ADDENDUM CC-3

March 19, 2010

GILA COUNTY PUBLIC WORKS PROJECTS  
GLOBE, ARIZONA

DLR GROUP PROJECT NOS. 30-09115-00 AND 30-09118-00  
BID DOCUMENTS NO. 110109-1

Attachment No. M1  
 to Addendum No. CC-3  
 Dated: March 19, 2010

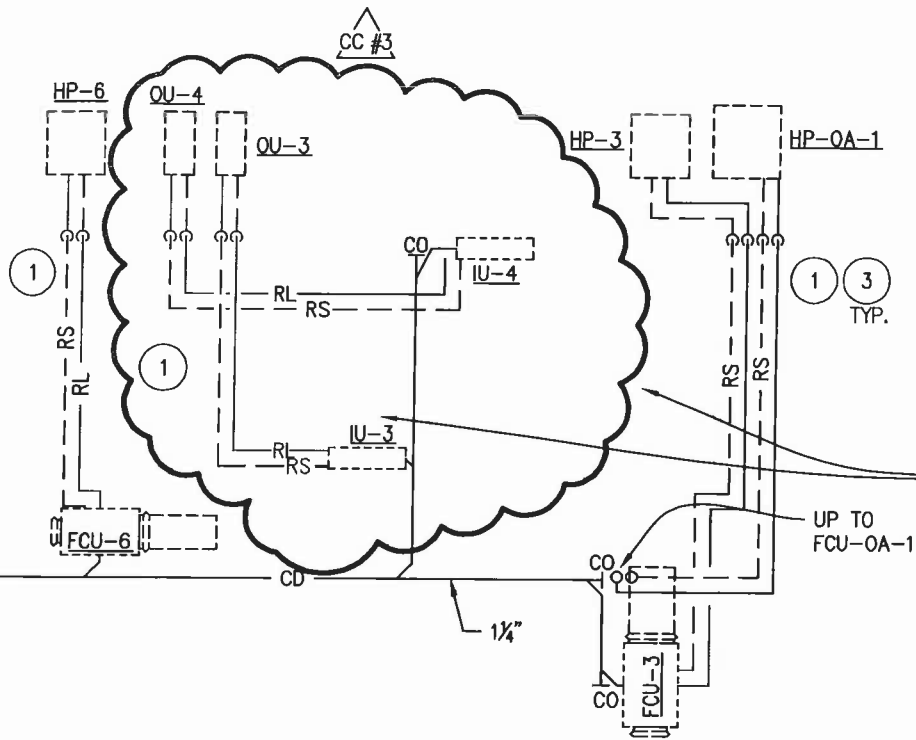
- a. Relocate IU-3 per Attachment M-1 to Addendum CC-3 dated March 19, 2010.

Attachment No. M2  
to Addendum No. CC-3  
Dated: March 19, 2010

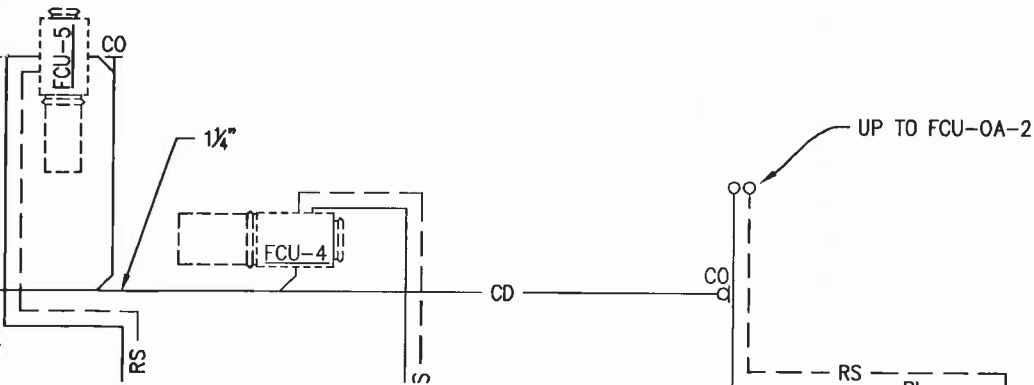
- a. Modify refrigerant and condensate piping per Attachment M-2 to Addendum CC-3 dated March 19, 2010.

Attachment No. M3  
to Addendum No. CC-3  
Dated: March 19, 2010

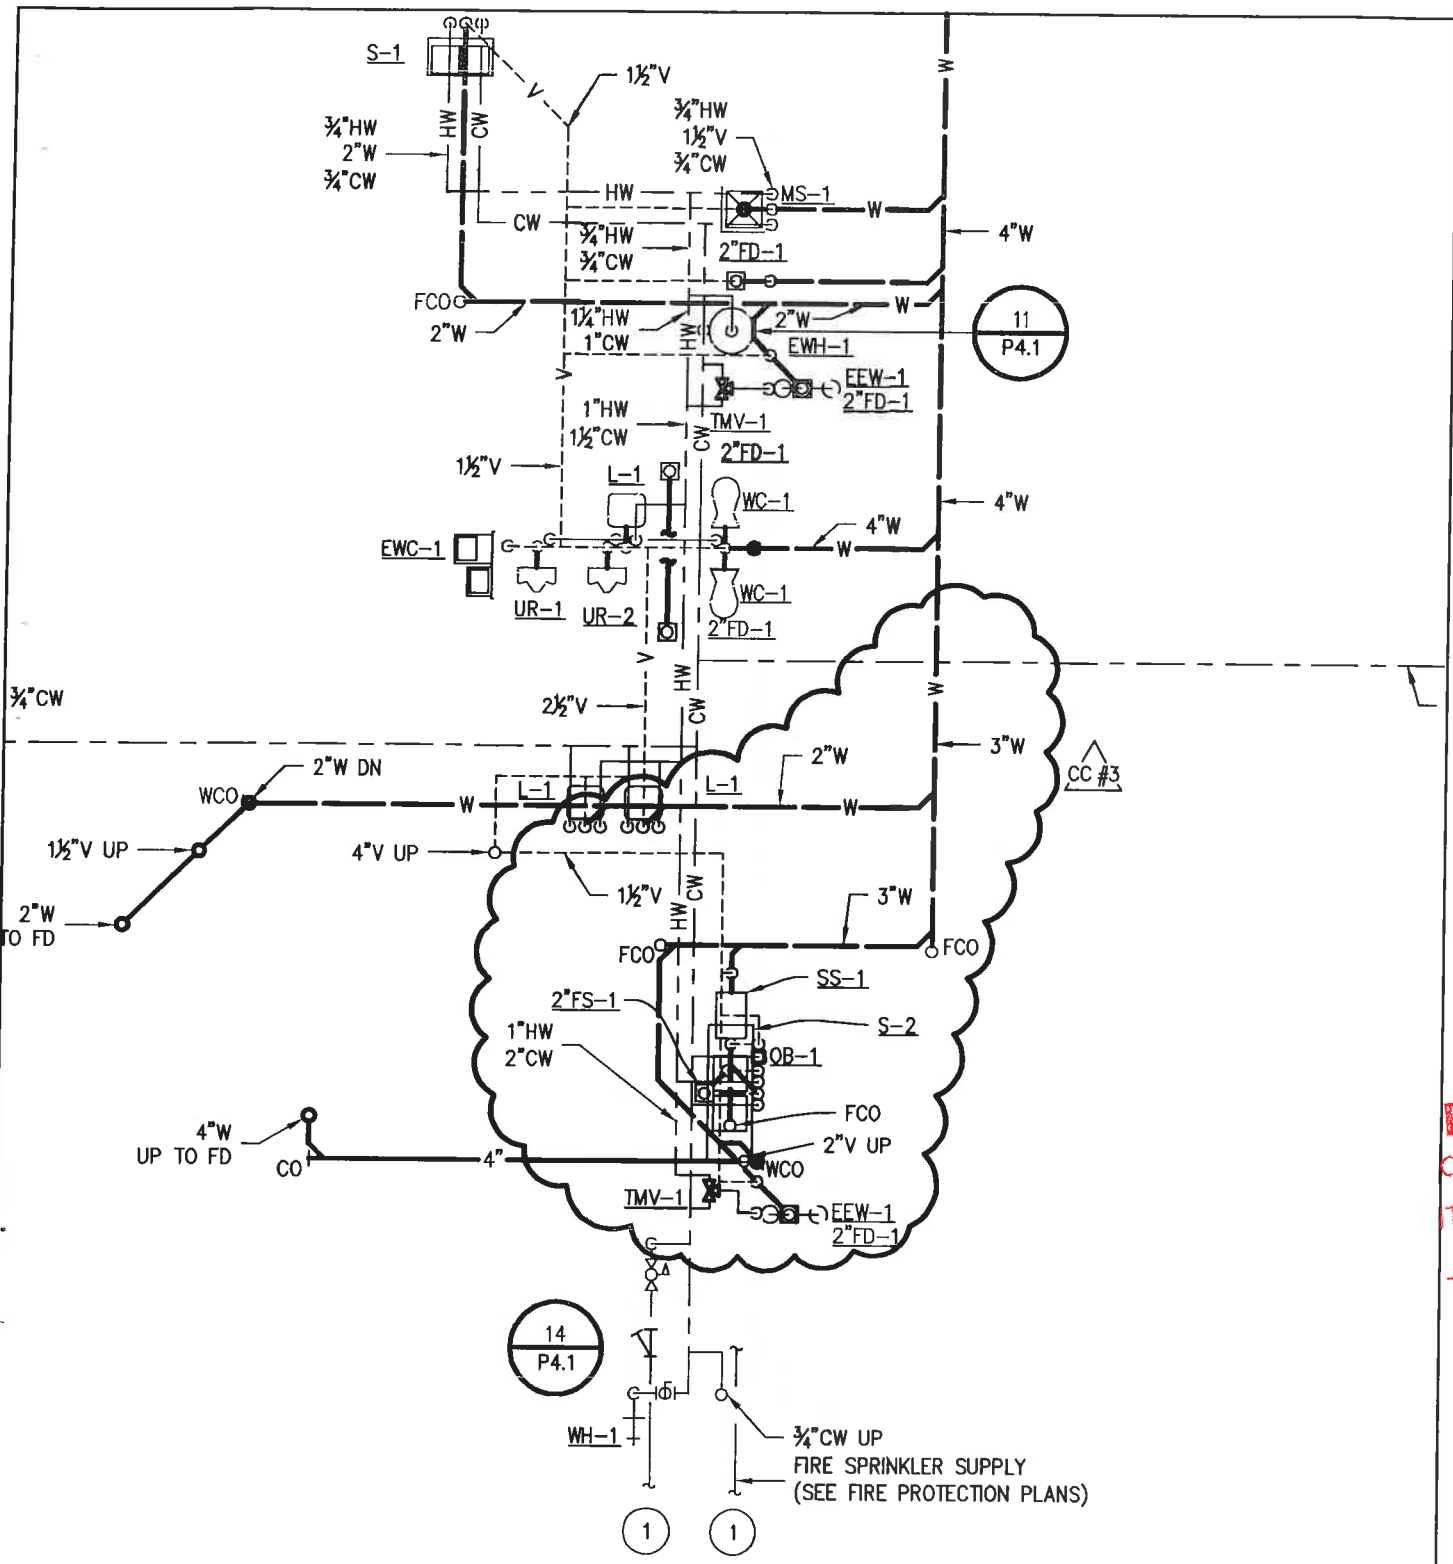
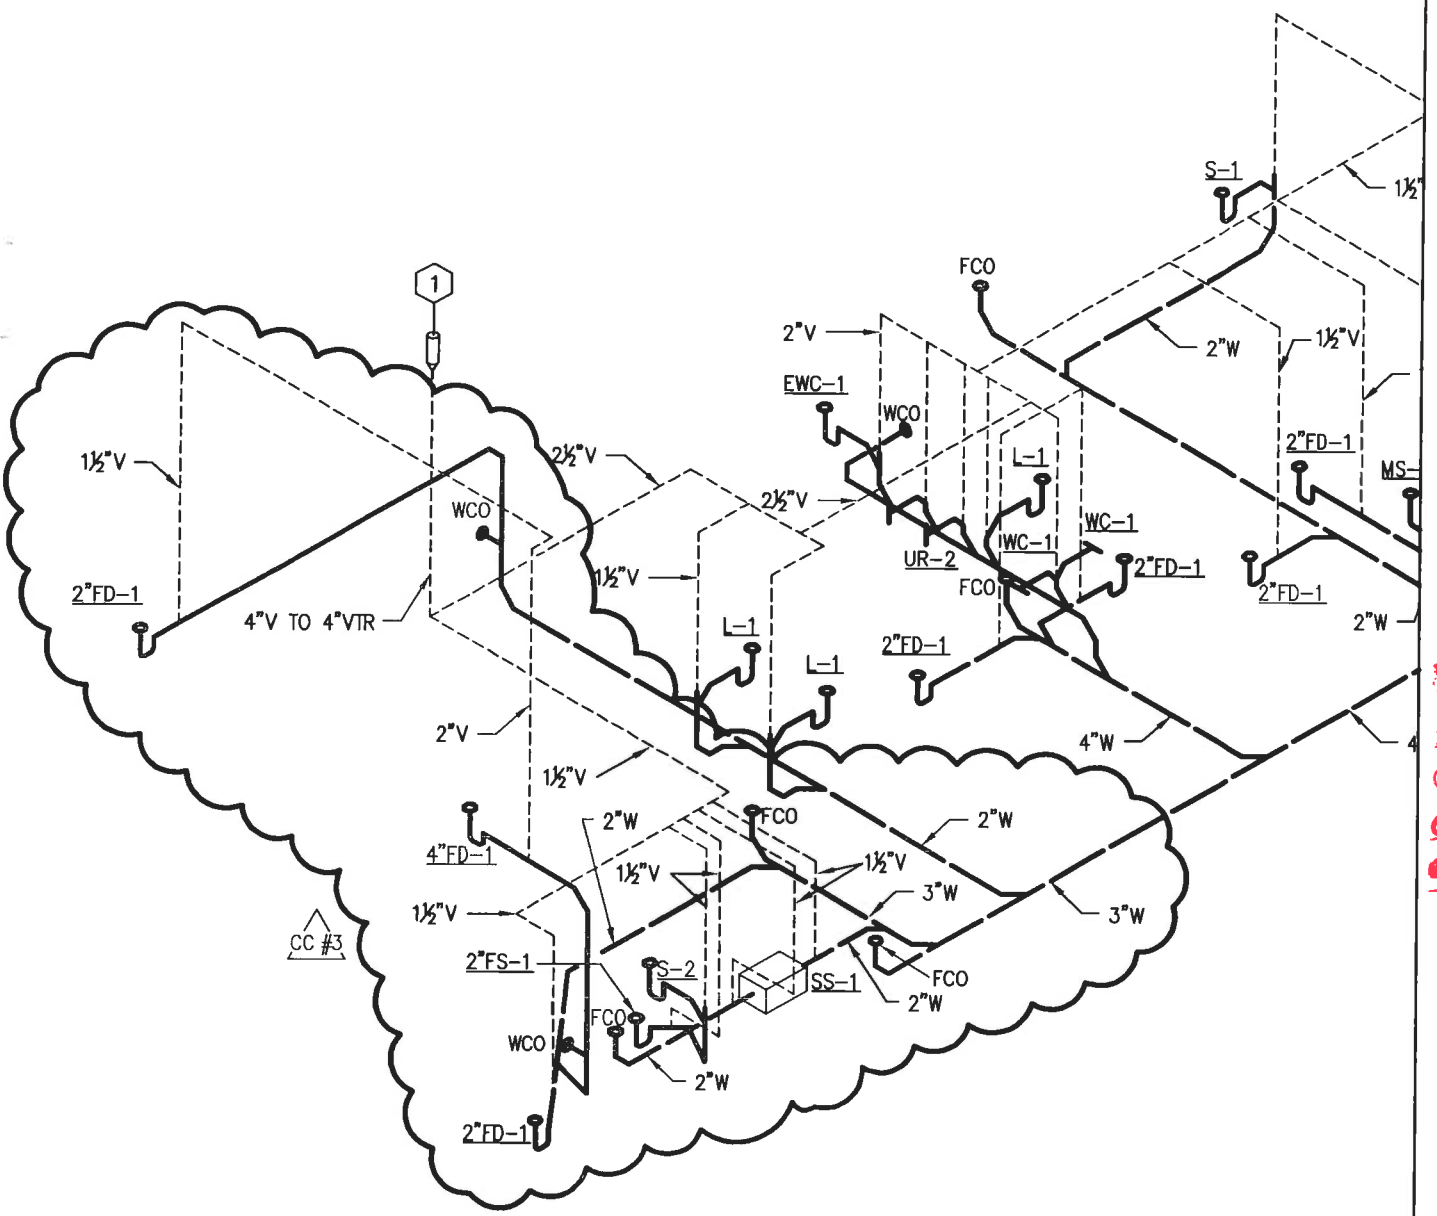
- a. Add S-2, SS-1, FS-1 and modify plumbing per Attachment M-3 to Addendum CC-3 dated March 19, 2010.

Attachment No. M4  
to Addendum No. CC-3  
Dated: March 19, 2010

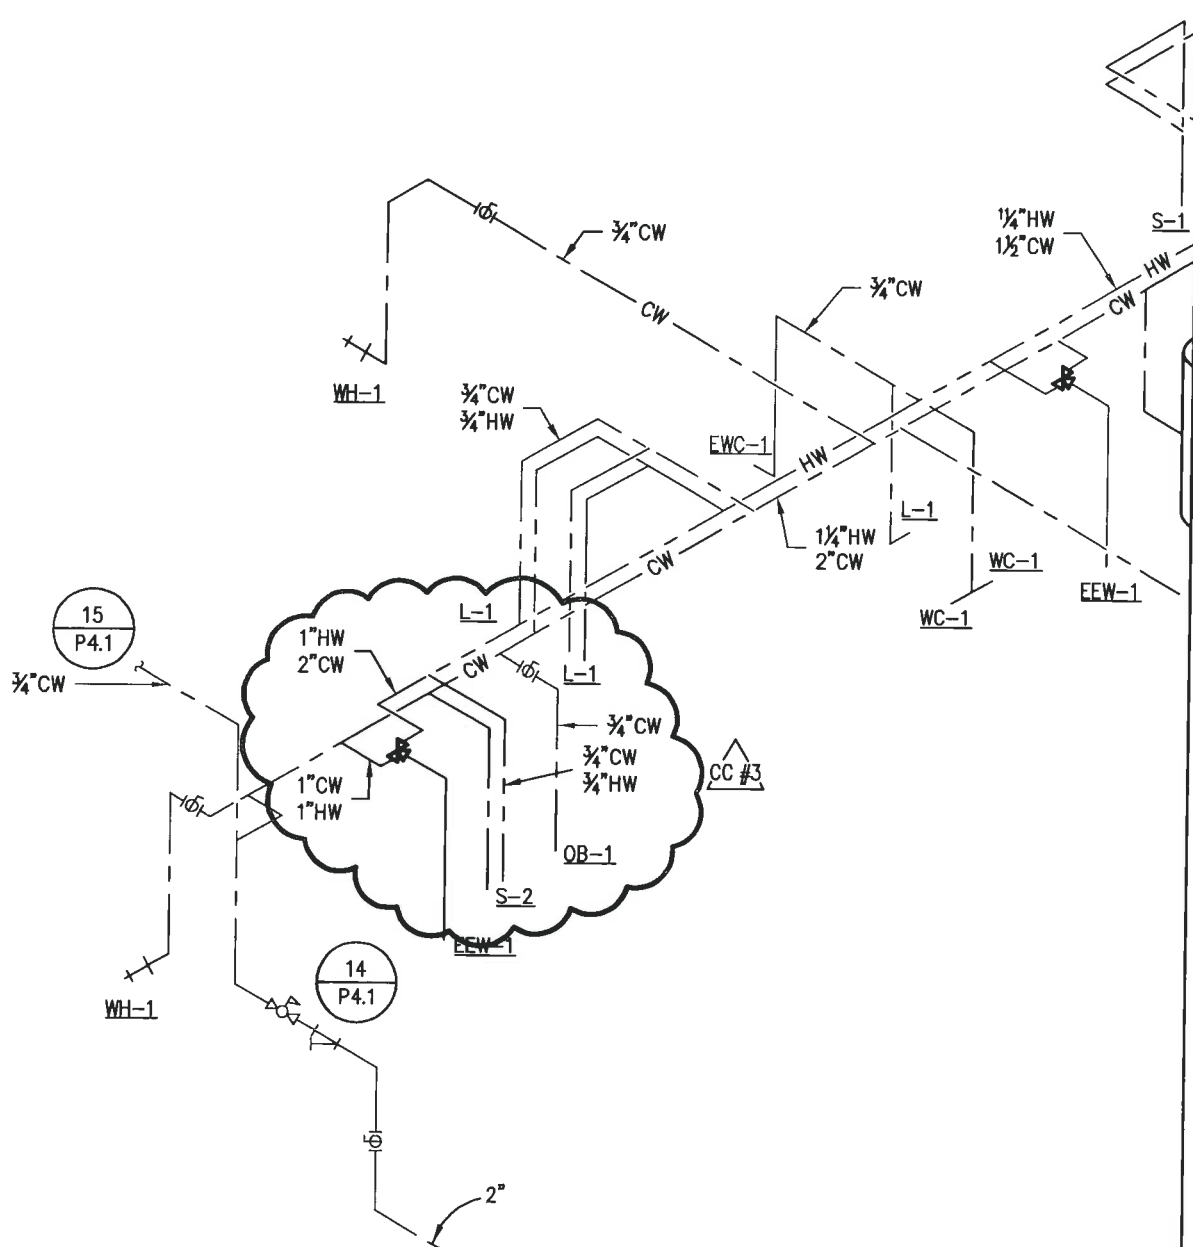
- a. Modify WASTE AND VENT RISER per Attachment M-4 to Addendum CC-3 dated March 19, 2010.
- b. Modify DOMESTIC WATER RISER per Attachment M-5 to Addendum CC-3 dated March 19, 2010.
- c. Modify PLUMBING FIXTURE SCHEDULE per Attachment M-6 to Addendum CC-3 dated March 19, 2010.
- d. Add SEPARATOR – SOLIDS SCHEDULE per Attachment M-6 to Addendum CC-3 dated March 19, 2010.

Attachment No. E3  
to ADDENDUM CC-3  
Dated: 19 March 2010

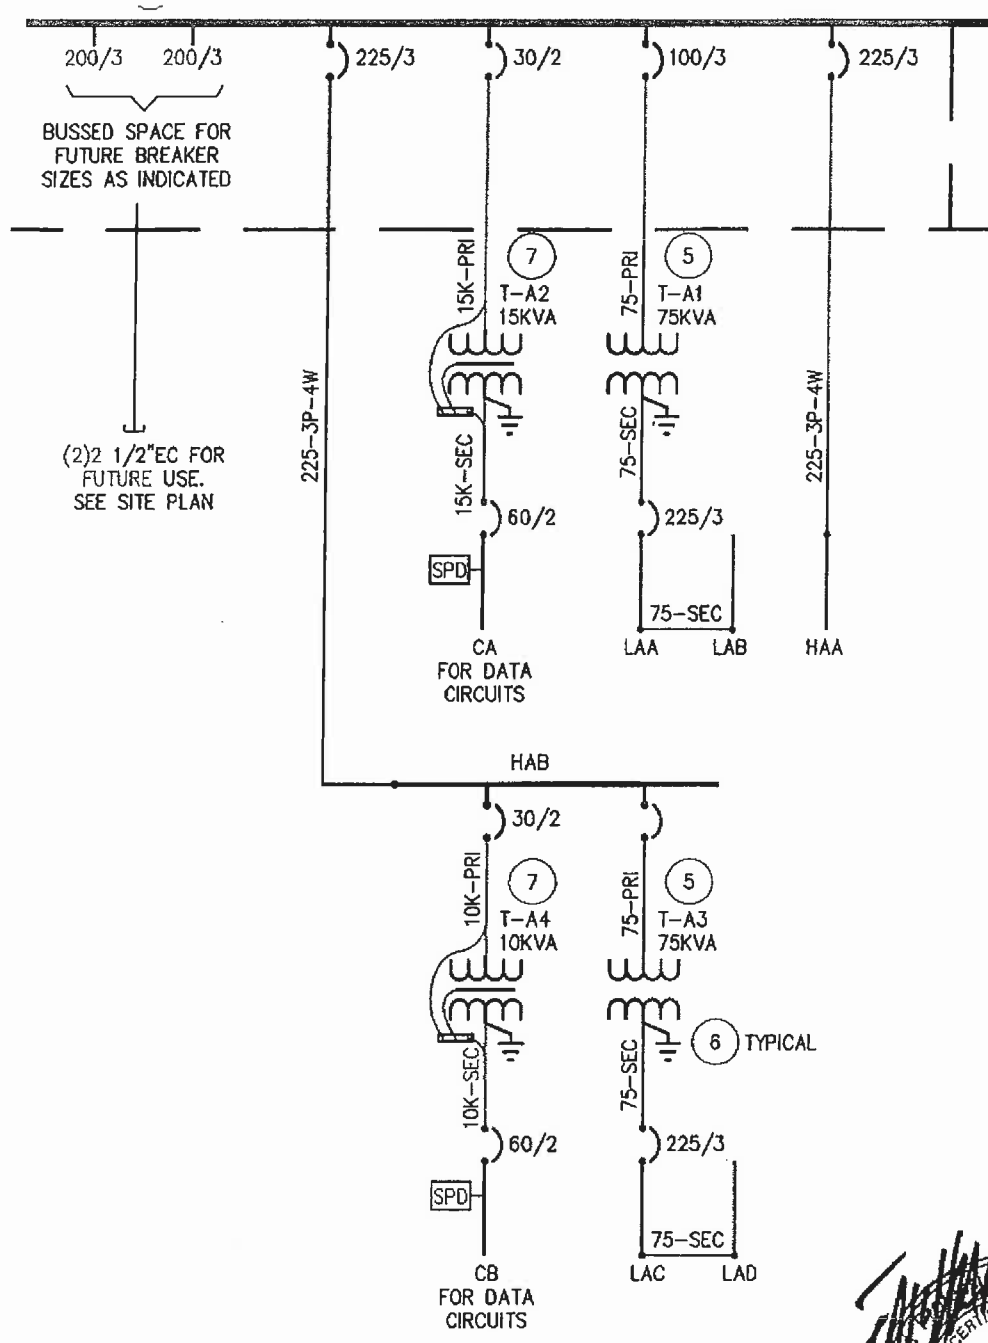
- a. From panel 'HAB' via transformers, delete the panel designations 'CF, LFA, LFB'. Add new designations 'CB, LAC, LAD' per Attachment E3 to Addendum CC-3 dated March 19, 2010.
